# Intel® Celeron® Processor in the 478-Pin Package

Specification Update

*September 2003*

Document Number: 290749-014

**Figure 12. System Bus Reset and Configuration Timings**

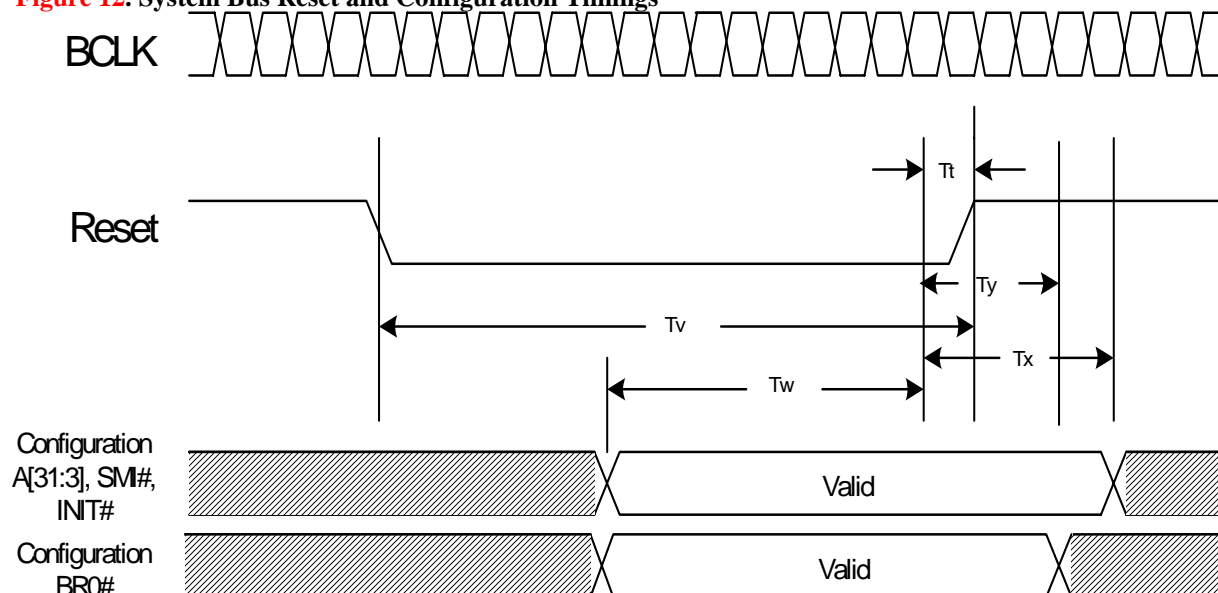
## V1 BR0# Maximum Hold Time Specification Change

The BR0# maximum hold time has changed to 2 BCLKs. This change will be shown in the “System Bus AC Specifications (Reset Conditions)” table and “System Bus Reset and Configuration Timings” figure of the *Intel (R) Celeron (R) Processor on .13 Micron Process in 478-Pin Package Datasheet*. This change will be incorporated in the next revision of the Datasheet.

The following figure will be modified to reflect this change:

Tv = T13 (RESET# Pulse Width)  
Tw = T45 (Reset Configuration Signals Setup Time)  
Tx = T46 (Reset Configuration Signals A[31:3], SMI#, and INIT# Hold Time)  
Ty = T47 (Reset Configuration signal BR0# Hold Time)
